WOLF CREEK GENERATING STATION

AMENDMENT TO FACILITY OPERATING LICENSE

Amendment No. 71
License No. NPF-42

ATTACHMENT TO LICENSE AMENDMENT NO. 71

FIGURE 3.4-2
REACTOR COOLANT SYSTEM HEATUP LIMITATIONS
APPLICABLE UP TO 13.6 EFPY

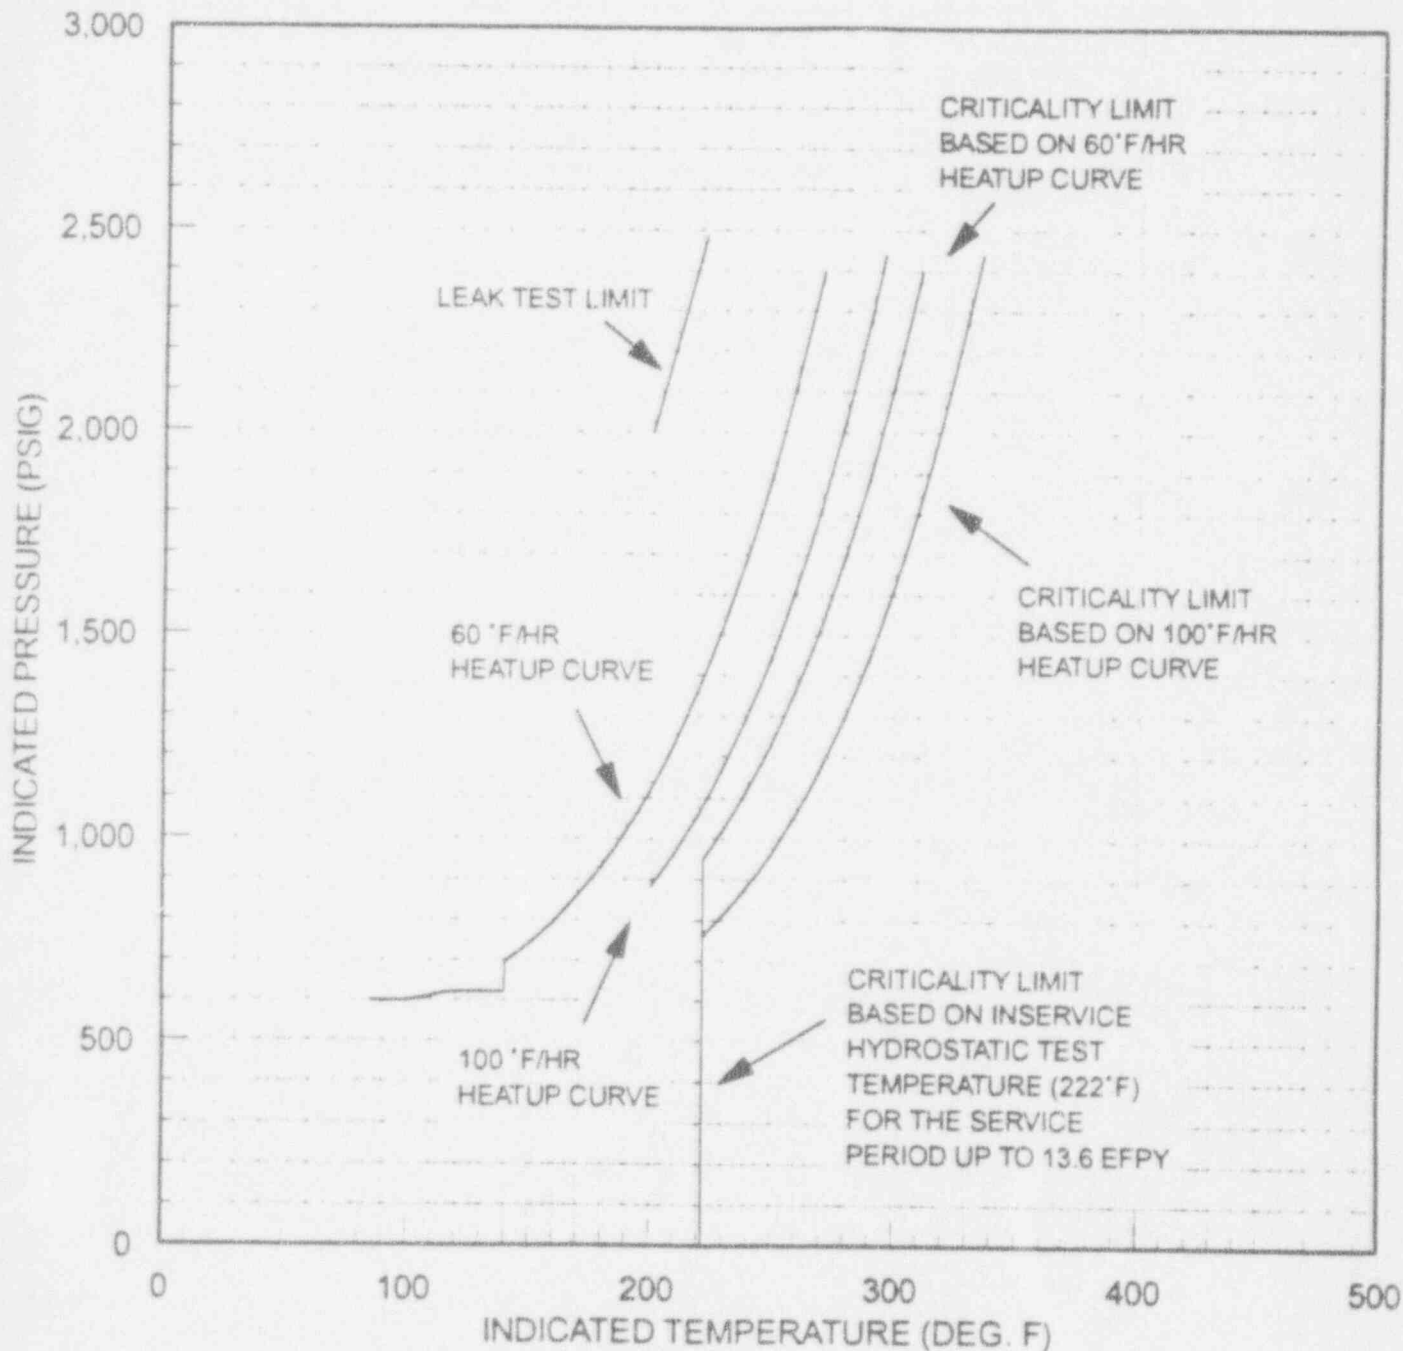
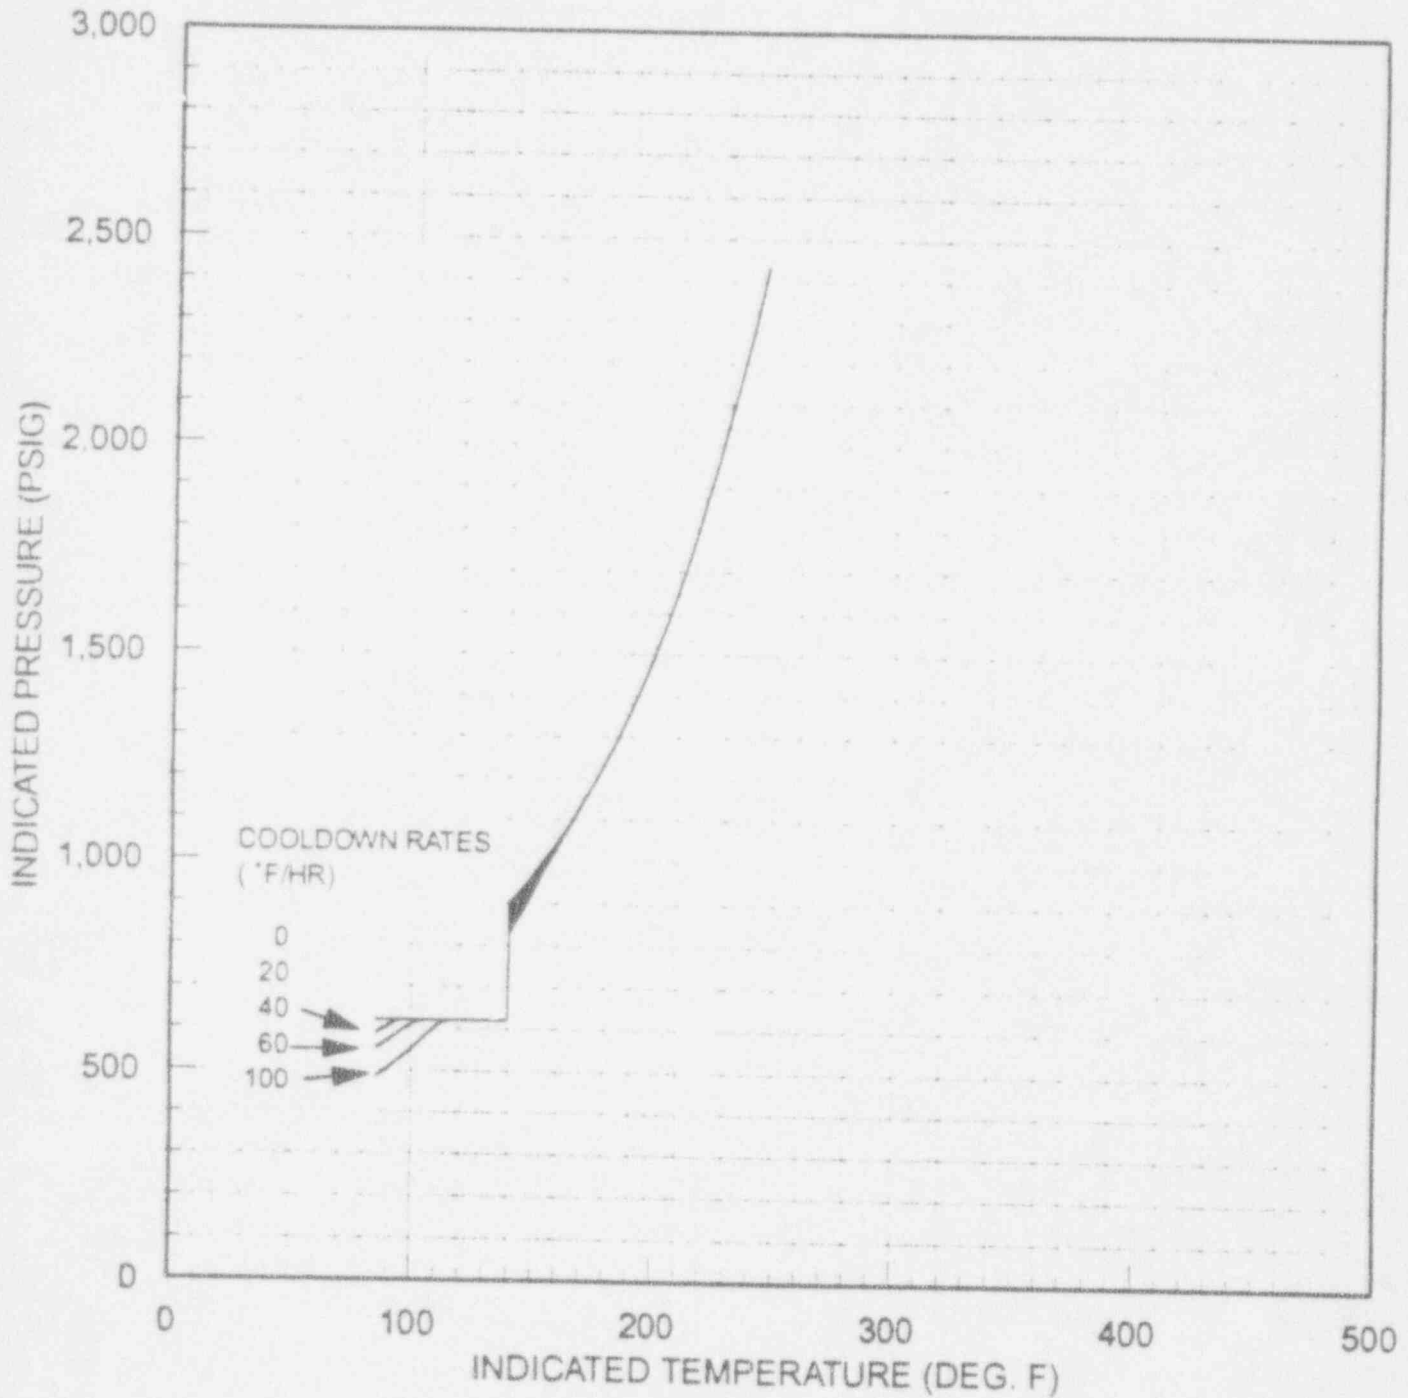
3.4.9.1 The Reactor Coolant System (except the pressurizer) temperature and pressure shall be limited in accordance with the limit lines shown on Figures 3.4-2 and 3.4-3 during heatup, cooldown, criticality, and inservice leak and hydrostatic testing with:

4.4.9.1.2 The reactor vessel material irradiation surveillance specimens shall be removed and examined, to determine changes in material properties, as required by 10 CFR Part 50, Appendix H. The results of these examinations shall be used to update Figures 3.4-2, 3.4-3, and 3.4-4. |

Controlling Material:	RV Lower Shell
Copper Content:	0.07 Weight %
Nickel Content:	0.62 Weight %
Initial RT _{NDT} :	40 °F
Limiting ART after 13.6 EFPY:	1/4T, 89 °F
	3/4T, 79 °F
